# 1963 - 1964 Corvette: Service Bulletin: 3-Speed Transmission Problems

**Subject:** 3-Speed Transmission Problems

**Source:** Chevrolet Technical Service Bulletin

**Bulletin No:** TSB #1008 DR #676

FIGURE 2 - MAST JACKET ASSEMBLY

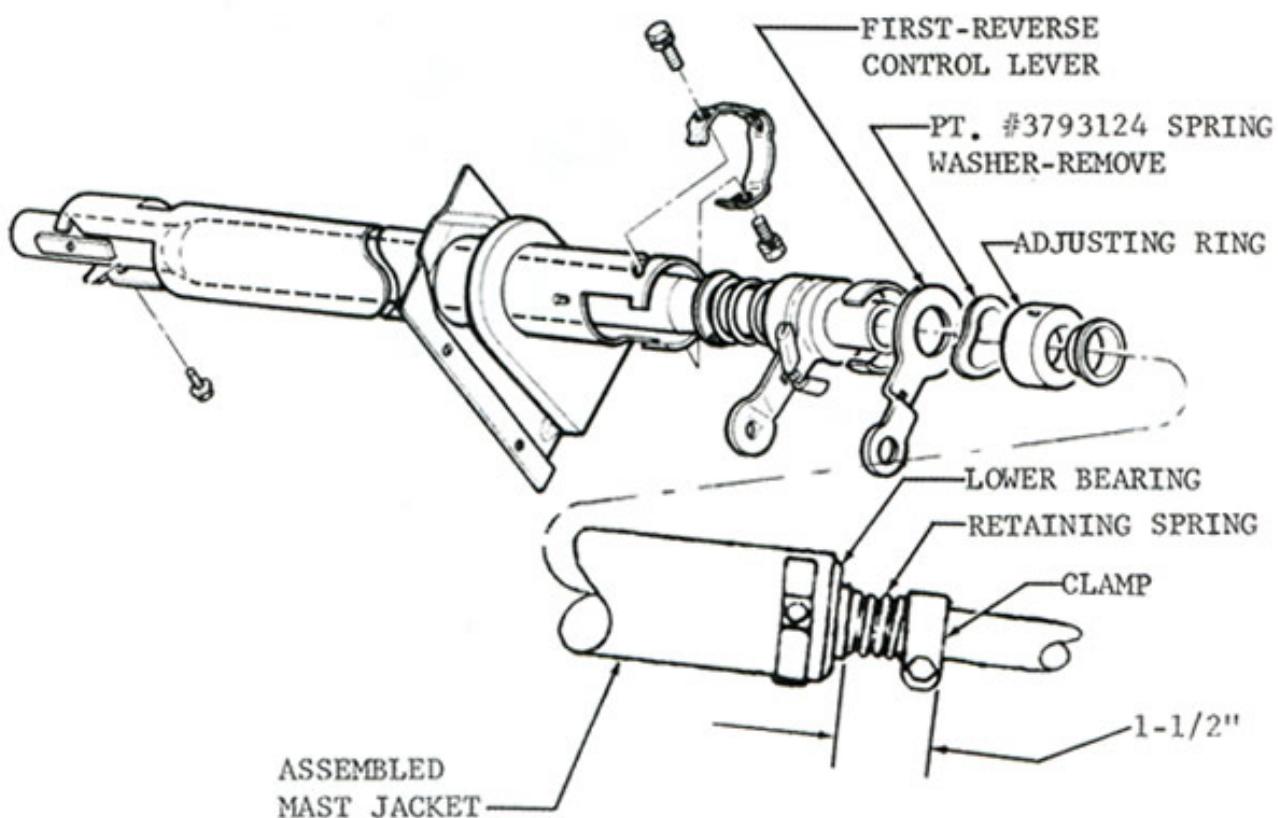
To provide a more positive shift on truck models, Part No. 3793124, transmission control 1st and reverse lever spring washer is being omitted in production and should be removed from units in service. The procedure to remove this spring washer and to readjust lever clearance is as follows:

1. Refer to Figure 2 for parts identification. Place shift lever in neutral; remove access cover from fender skirt.

2. Remove cap screws retaining adjusting ring to mast jacket.
3. Loosen steering shaft lower bearing retaining spring clamp.
4. Slide adjusting ring downward along steering shaft until Part No. 3793124, spring washer, is exposed. Cut and remove spring washer from steering shaft.
5. Apply lubriplate to thrust surfaces of control levers, relay lever and adjusting ring.
6. Position adjusting ring in mast jacket; align holes in ring with slots in mast jacket and install cap screws, but do not tighten.
7. Rotate adjusting ring upward until clearance of .005" exists between first-reverse control lever and ring as shown in Figure 3. Tighten cap screws.

8. Force lower bearing retaining spring clamp upward against spring tension until a dimension of 1-1/2" exists between lower bearing and clamp as shown in Figure 2. Tighten clamp bolt.
9. With transmission side cover selector levers in neutral position, adjust selector rod lengths per instructions in the appropriate shop manual to provide proper neutral cross-over. Replace access cover when adjustments are completed.

FIGURE 4 - INSTALLATION OF THRUST WASHERS IN CHEVY VAN

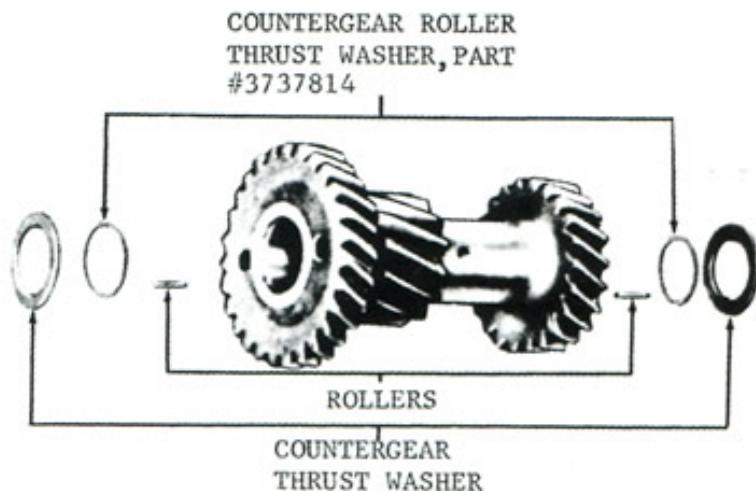
On Chevy Van models with three-speed transmissions, a small steel thrust washer is used between the countergear thrust washer and the countergear roller bearings at each end of the countergear. Since the 1964 Chevy Van Shop Manual is supplemented to the 1963 Truck Shop Manual in this area, reference to this part is omitted in error.

Figure 4 illustrates installed location of this thrust washer in Chevy Van transmissions.

NOTE: For service replacement procure (1) 3740819 Countergear Thrust Washer & (1) 3737814 Countergear Roller Thrust Washer for each steel thrust washer replaced. The roller thrust washer is installed between the countergear rollers and the countergear thrust washer.

FIGURE 5 - INSTALLATION OF MAGNETIC CHIP COLLECTOR

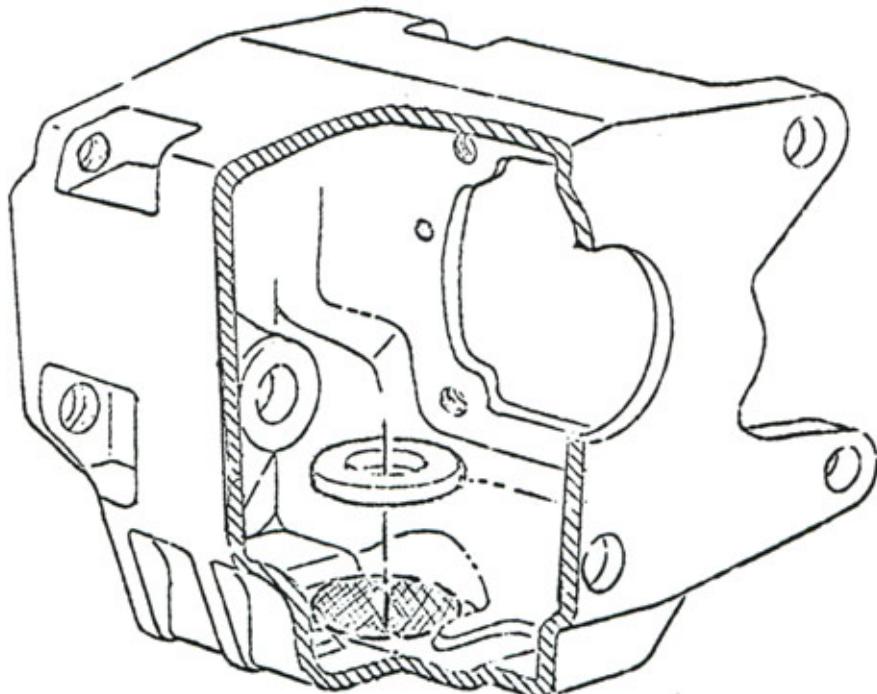
To reduce bearing noise and increase bearing durability, two changes have been released for production. First is the installation of a magnetic chip collector which went into effect on June 5, 1964. Second is the use of a new clutch gear and mainshaft bearing that incorporates a slinger ring on the inner race. This change went into effect on transmissions for use on 327 cu. in. engines on June 11, 1964, and is estimated to go into effect the week of June 22, 1964, on remaining transmissions.

Service Kit #3869240 has been released for field installation of the chip collector on 1963 and 1964 3-speed transmissions built prior to the above dates. The kit includes the magnet, cement, and instruction sheet. It also contains a 3/8 inch high pedal bumper for increasing clutch release on all except Chevy Van (Reference - Gear Clash - First and Reverse Shift). It is recommended that whenever a 1963 or 1964 3-speed transmission is disassembled for any reason, that the magnet be installed using the following procedure.

3. Wipe magnet and area in case where magnet is to be installed with Acetone or Toluol (available at most drugstores). Area where magnet is to be installed must be clean, dry and free from oil and grease film. When Acetone or Toluol is applied, be sure to use in ample quantity to neutralize grease and oil which may be in pores of casting surface. Do not touch cleaned area with hands.

4. Using cement supplied in kit, apply about a 1/16 inch thick film over entire bottom surface of magnet and immediately place in case as shown in sketch. Press straight down - do not twist while pressing in position. Note: If cement from tube appears to be thick, discard thick or hardened chunks and use cement from middle or bottom of tube.

5. To cure cement, place a trouble light with a 100 watt lamp inside of case as close to magnet as possible, and allow to stand for a minimum of 30 minutes. Use care not to touch magnet or knock it out of position. A heat lamp, if available, may be used in place of 100 watt lamp.
